Project	IEEE 802.16 Broadband Wireless Access Working Group < http://ieee802.org/16 >	
Title	Power Balancing for MIMO Precoder	
Date Submitted	2009-07-13	
Source(s)	¹ Hsuan-Jung Su, Chung-Pi Lee, Yu-Han Yang, Chun-Yao Chen, Wei-Shun Liao, NTU Ren-Jr Chen, Chung-Lien Ho, Chang-Lan Tsai, Zheng Yan-Xiu, ITRI	Voice: ¹ +886-2-33663600 E-mail: ¹ hjsu@cc.ee.ntu.edu.tw * http://standards.ieee.org/faqs/affiliationFAQ.html >
Re:	IEEE 802.16m-09/00028 "Call for Comments and Contributions on Project 802.16m Amendment Content"	
Abstract	This contribution addresses the high PAPR issue related to MIMO precoding and IFFT. It is suggested that a general remedy to the PAPR issue without introducing signal distortion or side information feeding forward should be considered in 802.16m. A method based on constellation shaping to balance the signal power, such that the high PAPR caused by precoding and IFFT can be reduced, is also provided in this contribution as an example of such general remedies.

Power Balancing for MIMO Precoder

Figure 514 -- UL MIMO architecture

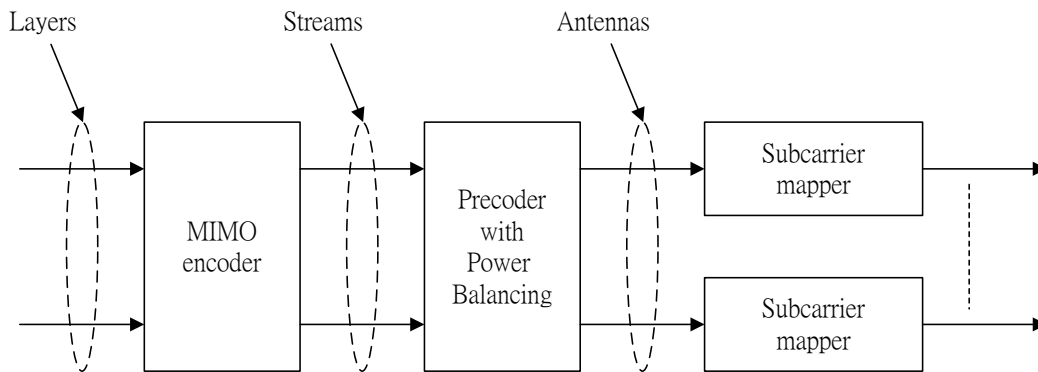
Modify Figure 514 as follows.

Figure XXX – Precoder with Power Balancing

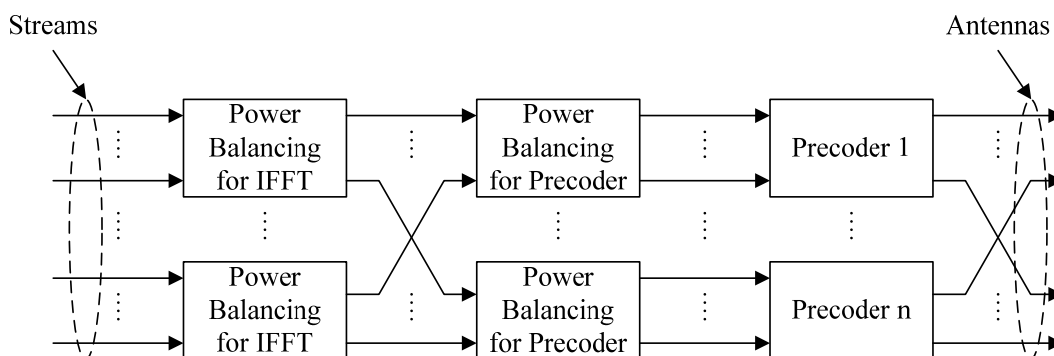
Add the following section on power balancing for the precoder and IFFT.

Power balancing can be performed to alleviate the high peak power problem caused by the precoder and IFFT.

The precoder block with power balancing is shown in Figure XXX. The power balancing operations are in the order of power balancing for IFFT first, then power balancing for precoding. Power balancing for precoding is an integer-to-integer mapping which is an approximation of the inverse of the precoding matrix, where integer means Gaussian integer defined on the grid of the signal constellation. For any precoding matrix, the integer-to-integer mapping of the power balancing operation is factorized into a series of Integer Reversible Matrix Mapping (IRMM)
